U.S. ENVIRONMENTAL PROTECTION AGENCY
REGION 10
SEATTLE, WASHINGTON 98101

SUBJECT: EPA Response to Alaska Dept. of Environmental Conservation Air Quality Comments on PSD IV Technical Analysis for ARCO/SOHIO PSD IV Application

PRELIMINARY DETERMINATION DOCUMENT
PREVENTION OF SIGNIFICANT AIR QUALITY DETERIORATION
PROPOSED MODIFICATION OF THE PRUDHOE BAY OIL FIELD AT
PRUDHOE BAY, ALASKA

Figure 3 ... Typical Stationary Source Grid

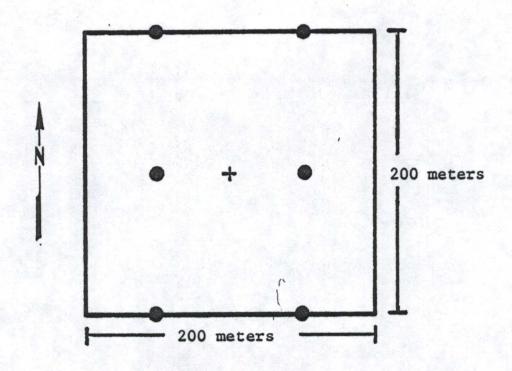
ADEC Comment 9 - The random grid distribution used in the modeling analysis may result in an underestimation of ground-level pollutant concentrations.

<u>EPA Response</u> - The applicant used the random grid distribution in the air quality analysis for the sources because the

location, number, and sizes of specific future modules is changing as the design process continues. For this reason, use of this grid system is probably the most appropriate approach to the spacing of sources in the air quality analysis. There is some amount of uncertainty in all input parameters used in air quality models (e.g. meteorology, emission rates). Use of this grid system should not significantly add to the uncertainty of the final modeling results.

Figure 4-1. Calculated Annual Average  $NO_2$  Concentrations ( $\mu g/m^3$ ) for All Sources Including Background.

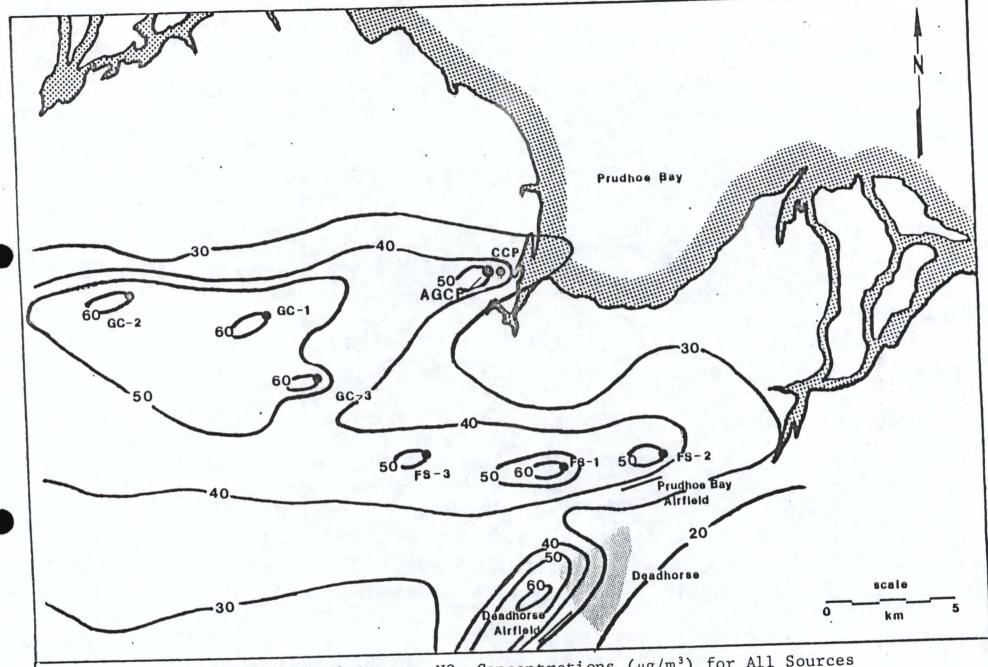
$\frac{\text{ADEC Comment 10}}{\text{impacts listed in the PSD I Application with general NO}_2$  impacts listed in the PSD IV Application because different models were used for each application.

EPA Response - EPA acknowledges that comparison of the TCM Model results of the PSD I Application with the ISC Model results of the PSD IV Application is not completely valid. However, using the TCM results in Figure 4-1 of the technical note entitled "Air Quality Impacts of the Prudhoe Bay Unit PSD-IV Sources as Estimated by the Texas Climatological Model (TCM-1)" in the comparison with the TCM results in the PSD I Application is still not completely valid due to the following: 1) Different sets of meteorological data were used in the modeling analyses of each application. 2) Impacts from the proposed AGCF sources were not included in the results displayed in Figure 4-1 of the above technical note.
